RENESAS TECHNICAL UPDATE

Product Category	MPU/MCU		Document No.	TN-RX*-A0225A/E	Rev.	1.00
Title	Errata to User's Manual: Hardware Regarding the I ² C-bus Interface (RIIC)		Information Category	Technical Notification		
Applicable Product	RX62N Group, RX621 Group, RX21A Group	Lot No.	Reference Document	RX62N Group, RX621 Group User's Manual: Hardware Rev.1.40 (R01UH0033EJ0140) RX21A Group User's Manual: Hardware Rev.1.10 (R01UH0251EJ0110)		
		All

This document describes corrections to the "I²C Bus Interface (RIIC)" chapter in User's Manual: Hardware for the applicable products.

Figure 31.28 Set/Clear Timing of the AASy and DID Flags during Reception of Device-ID Address

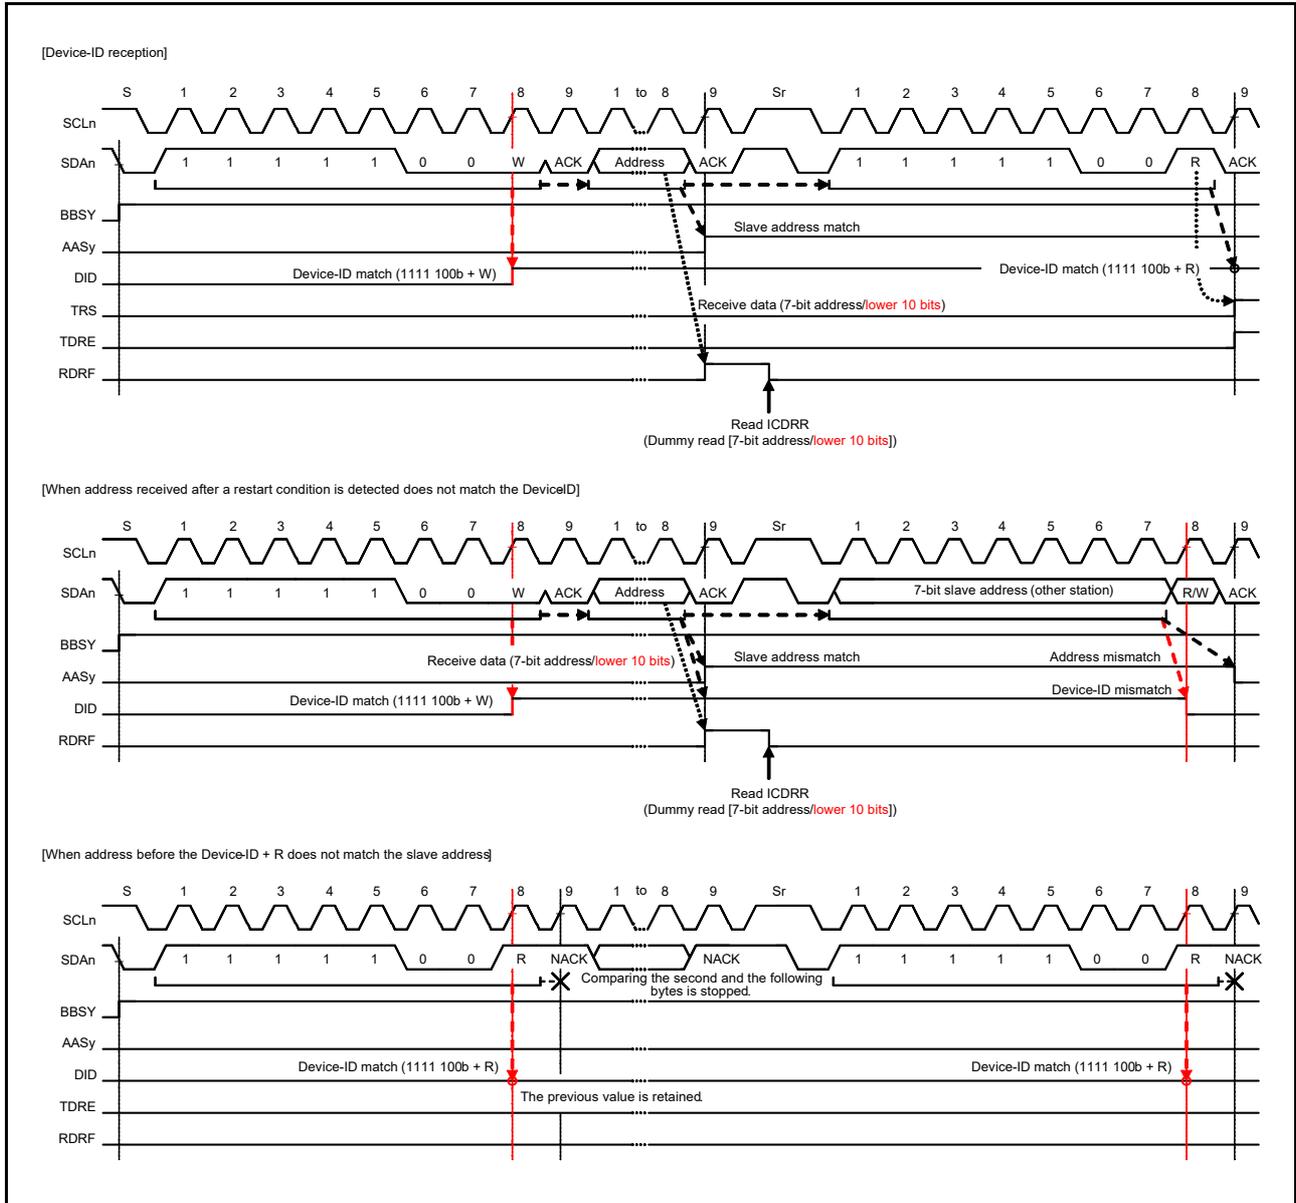
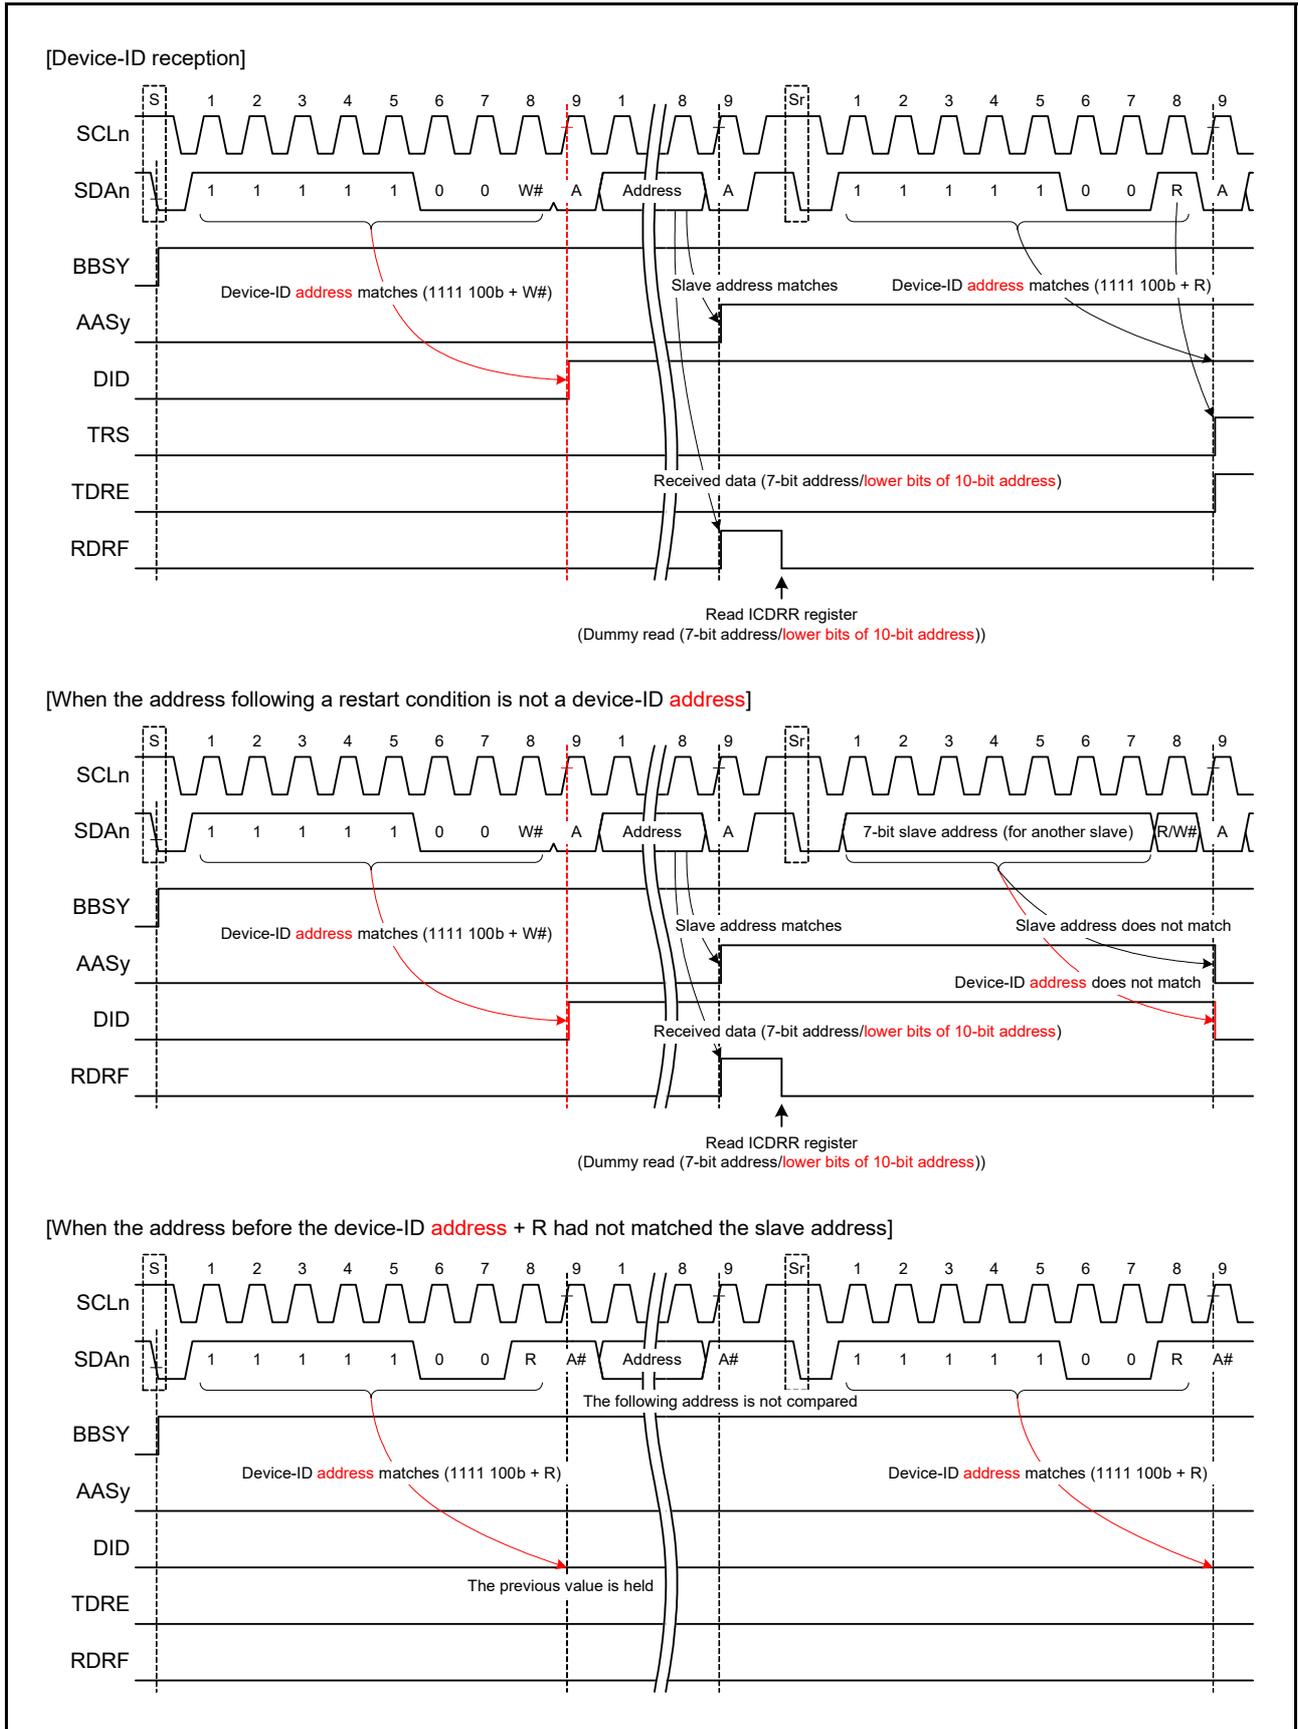
Figure 31.28 in section 31.7.3, Device-ID Address Detection is corrected as follows.

Figure 31.31 Suspension of Data Transmission When NACK is Received (NACK = 1)

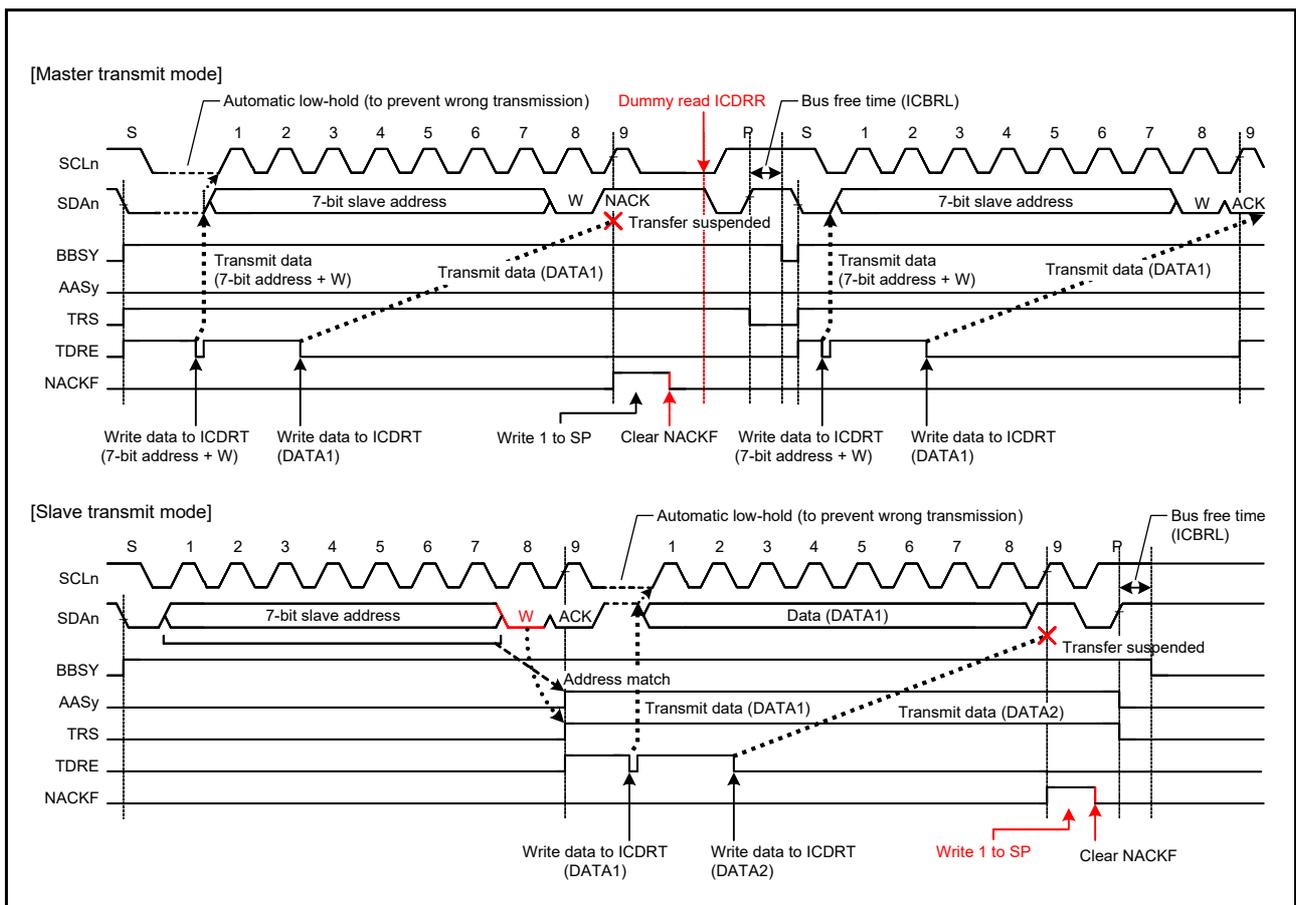
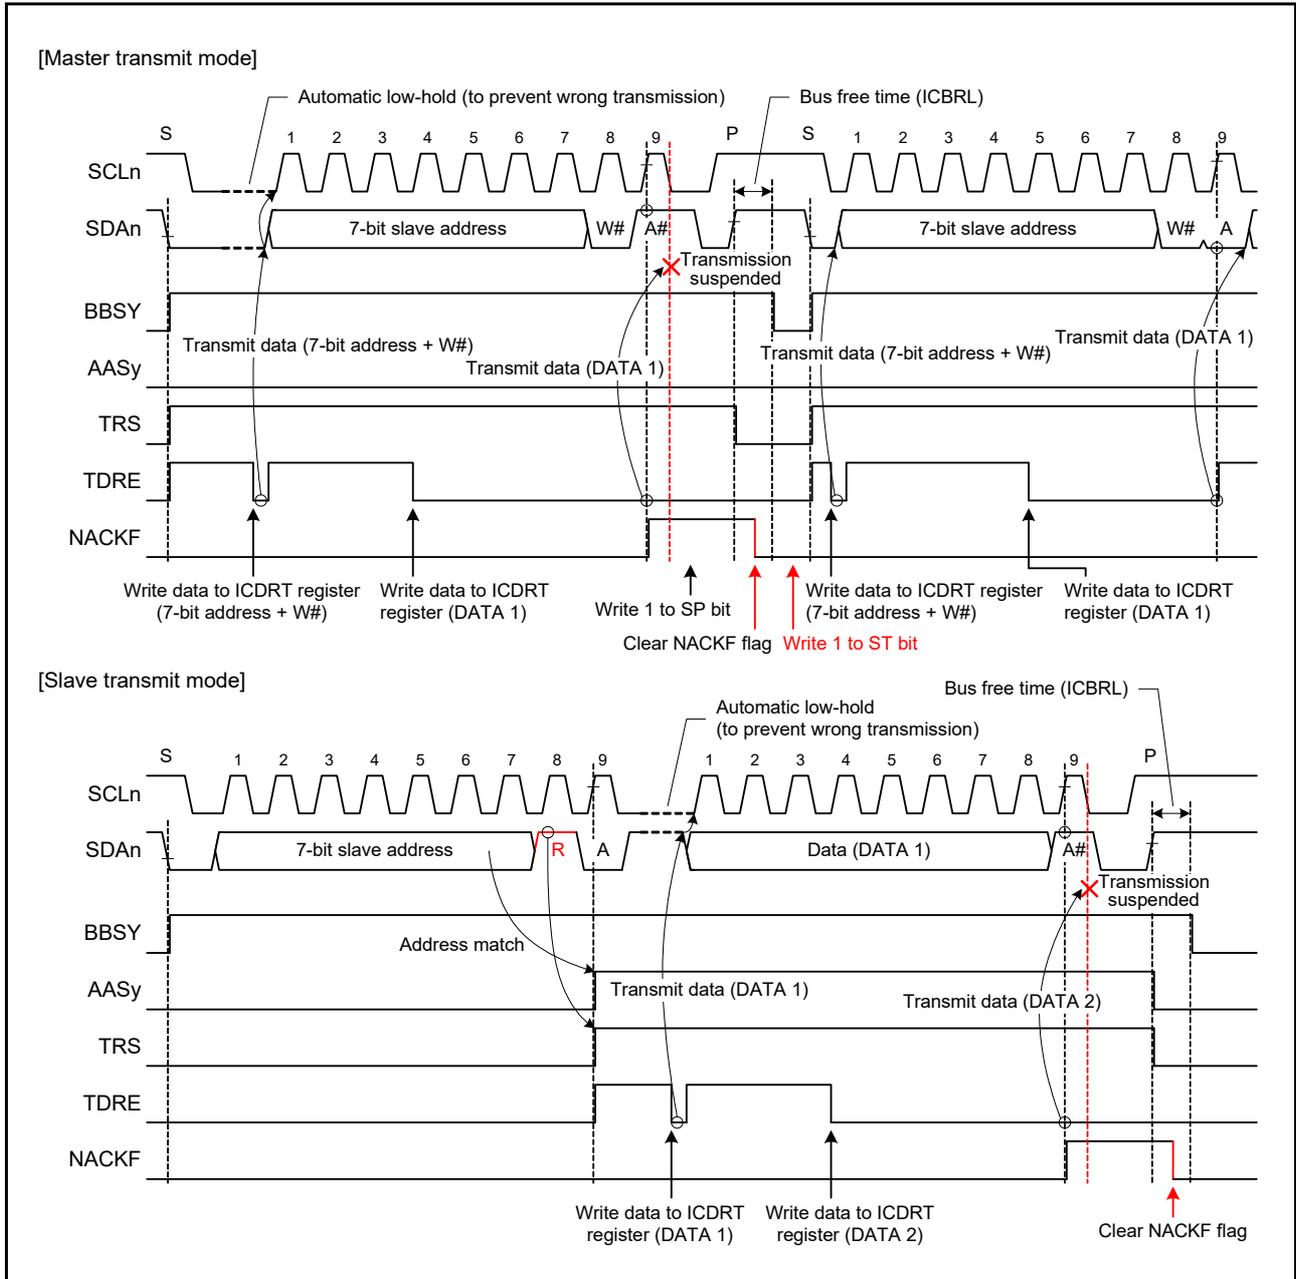
Figure 31.31 in section 31.8.2, NACK Reception Transfer Suspension Function is corrected as follows.

Figure 31.40 Additional SCL Output Function (CLO Bit)

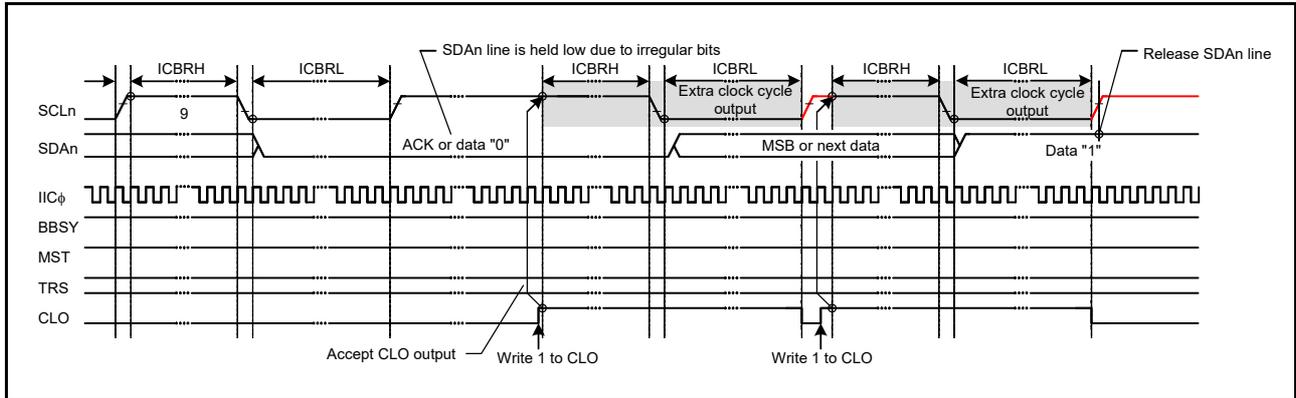
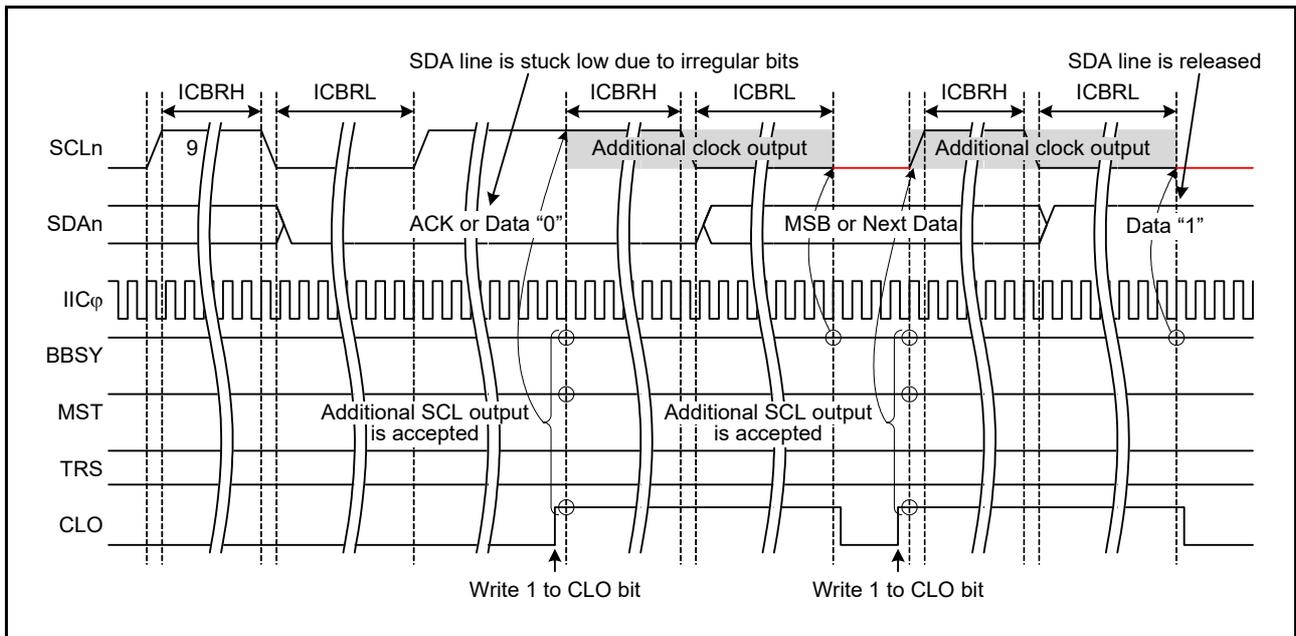
Figure 31.40 in section 31.11.2, Extra SCL Clock Cycle Output Function is corrected as follows.
